**June 14, 2016**  
**Medway Planning and Economic Development Board Meeting**  
**155 Village Street**  
**Medway, MA 02053**

## **2 Marc Road Site Plan – Public Hearing Continuation**

**RE: 2 MARC ROAD MEDICAL MARIJUANA SITE PLAN AND SPECIAL PERMITS**

**Re: Major Site Plan Review  
Proposed Marijuana Cultivation Facility  
2 Marc Road  
Medway, Massachusetts**

Photograph 7

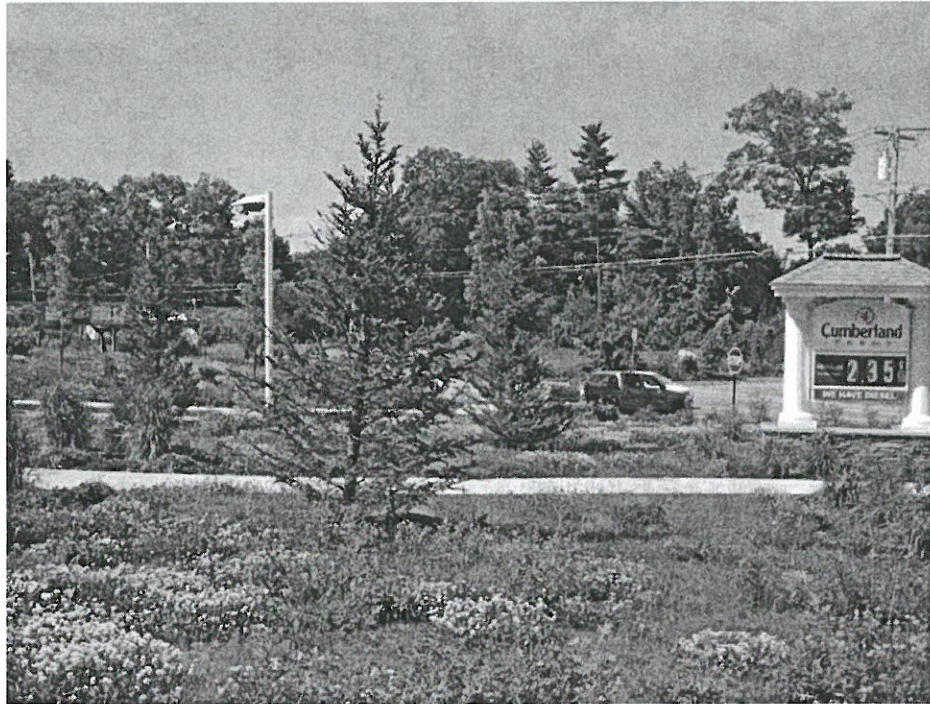
2. Various trees located throughout the site have either died or are in the process of dying due to a lack of proper maintenance. TT recommends these trees be removed and replaced in kind with species designated on the plant material list. The Applicant shall then maintain these trees in accordance with the Decision. (See Photo 6-9)

Photograph 15

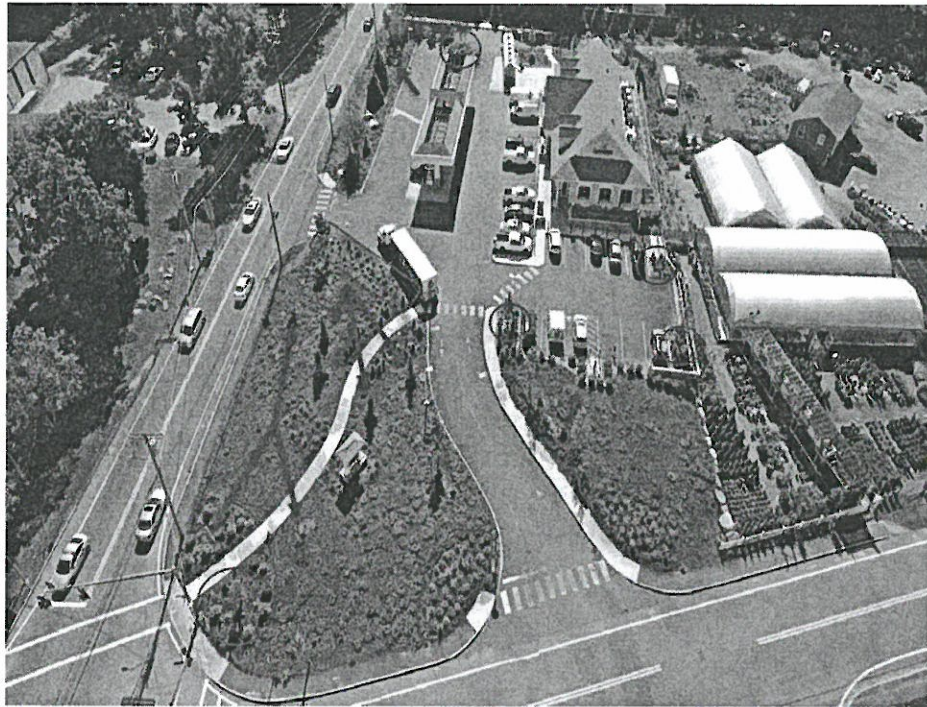
3. Various flowers, groundcover and shrubs have either died or are in the process of dying due to a lack of proper maintenance. TT recommends these plants be removed and replaced in kind with species designated on the plant material list. The Applicant shall then maintain these plants in accordance with the Decision. (See Photo 10-14)

Photograph 1

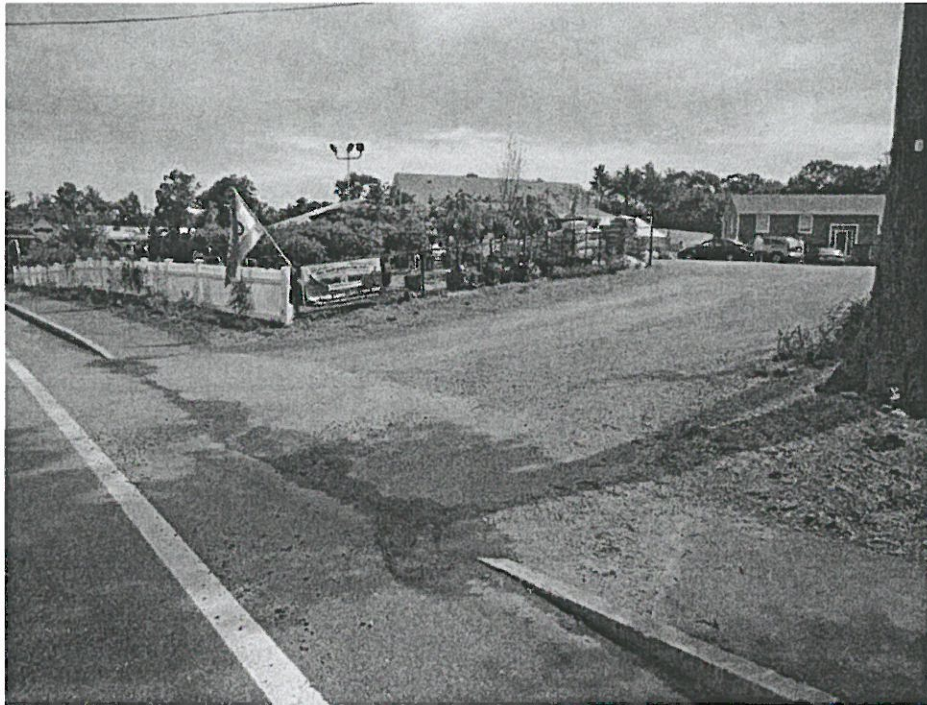
1. Proposed Bituminous Pavement driveway apron and appurtenant railroad ties have not been installed. (See Photo 1-2)
2. Proposed Bituminous Pavement parking area south of the wooden pergola has not yet been installed. (See Photo 3)
3. Proposed Pavement markings and striping (2 coats of paint required) has not yet been installed. (See Photo 4)
4. Proposed Directional and Accessible Signs have not yet been installed. (See Photo 4-5)
5. Proposed Concrete Wheel Stops have not yet been installed in any of the locations shown on the Site Plan. (See Photo 4-5)
6. It appears the Gravel Access drive to Milford Street has not yet been formally installed. An overgrown gravel path exists but it appears it is not what was intended on the Site Plan. (See Photo 5)

Photograph 5

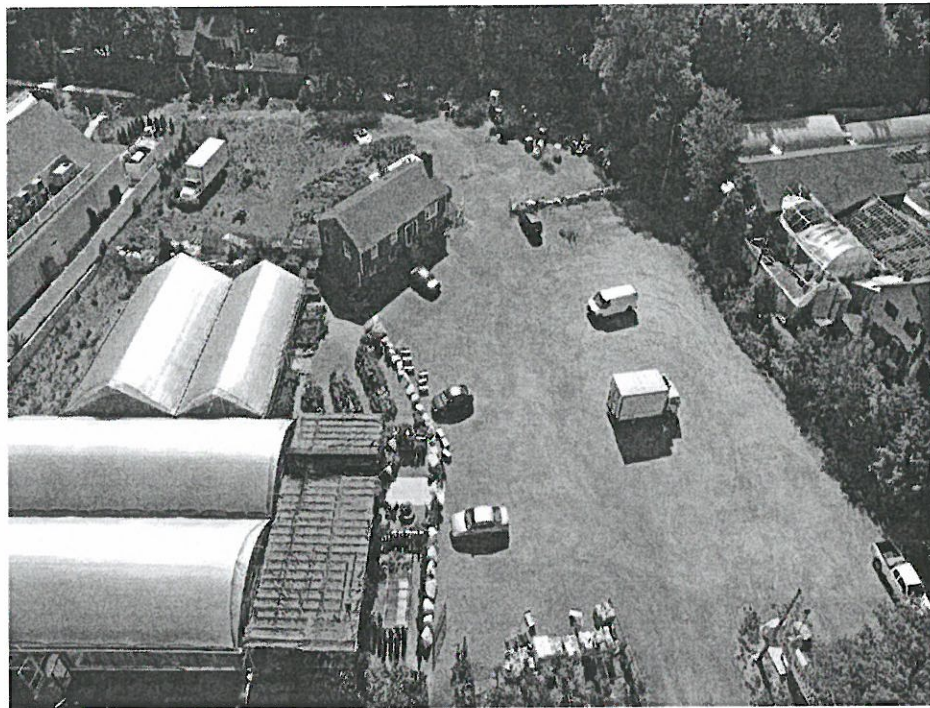
7. The "Medway Garden Center" sign has not yet been relocated with new plantings. (See Photo 5)
8. Evergreen Trees every 20' have not yet been planted along the southern property line. (See Photo 5)
